PDS010
Version: 1
Issued: 04/03/2022

$\varnothing/\varnothing_1$	S	DE	L	L ₁	Kg	Code
HDPE RING SEAL ADAPTOR WITH CAP						
160	6.2	188	130	30	0.53	927.160B

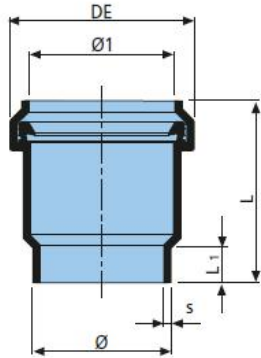
Before

After

For end cap add code 9130.160B

- Manufactured to BS EN 1519
- UK Manufactured
- Can be electrofusion welded or butt welded
- Witness lines at 45deg increments
- Extended spigot to allow for insertion of ring seal socket
- Dust cap available to order separately - code 9130.160B
- Can adapt to 6inch PVC or HDPE (please refer to thermal expansion tech bulletin 2017 bulletin 2) (only 160mm)

Table						
Code	Γ/Γ_1	S	DE	L	L ₁	K ₁
927.160B	160	6.2	192	184	85	70
